BEFORE THE OHIO POWER SITING BOARD

In the Matter of the Application of)	
Blossom Solar, LLC for a Certificate of)	Case No. 22-151-EL-BGN
Environmental Compatibility and Public)	
Need)

NOTICE OF FILING RESPONSES TO STAFF’S SUPPLEMENTAL DATA REQUESTS

Blossom Solar, LLC's September 6, 2022 Responses to Staff's August 19, 2022 Data Requests

MV AC TRENCH
NOT TO SCALE

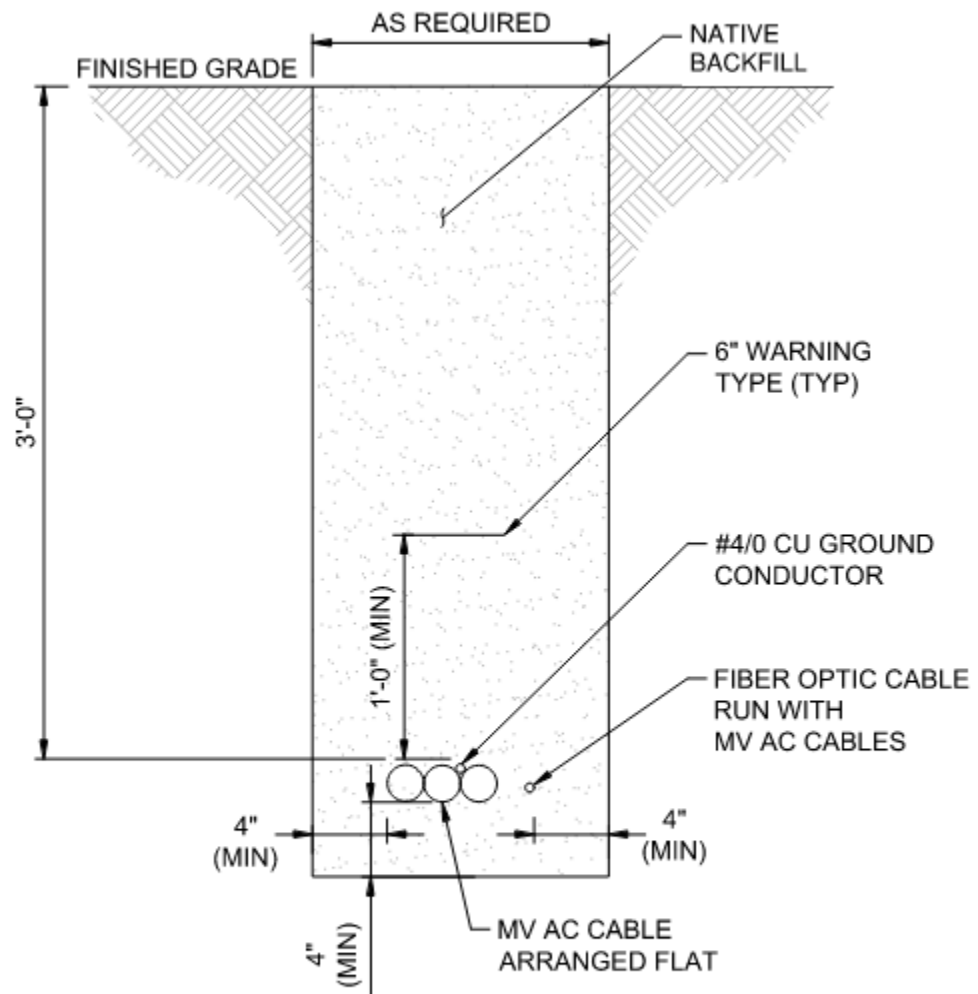
- c. A cross section of the cable trench, including anticipated depth and fill material**

***Response:** See image below for a representative depiction of the cabling trench, anticipated depth, and material used on Blossom Solar. This information is preliminary and subject to change as part of the final site design.*

Oil & Gas Well Map
Blossom Solar Project
Morrow County, Ohio

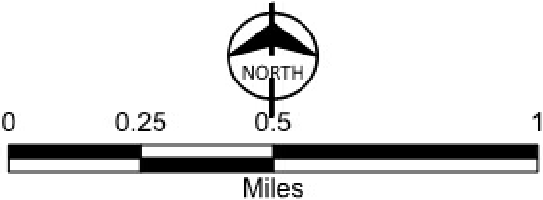
1. In review of the docket entry of July 25, 2022, summarizing Staff data requests to date, Attachment II of that response identifies seven oil and gas well permits, two of which are said to be within the project area, and both of which were summarized as permitted but never drilled as those permits have expired. Staff's review of the ODNR public data indicates that only one of these two permitted locations are within the project area, but more importantly, two wells that were drilled are not accounted for in the data request response. Please review and revise as necessary, Staff's previous request to: Please identify these wells by their assigned API number and confirm whether these wells have been plugged. In addition, provide minimum distances between these wells and any proposed project infrastructure.

Response: Please see Attachment 1 for a map showing the locations of oil and gas wells pulled from ODNR's online data base in relation to Blossom's Project Area. The embedded table shown in the upper right-hand corner of the map confirms which wells are located within the Project Area and the distance between these wells and any proposed project infrastructure. Two plugged wells (API 34117235930000 and API 34117600310000) and one permit expired well (API 34117236080000) are located within the project area.
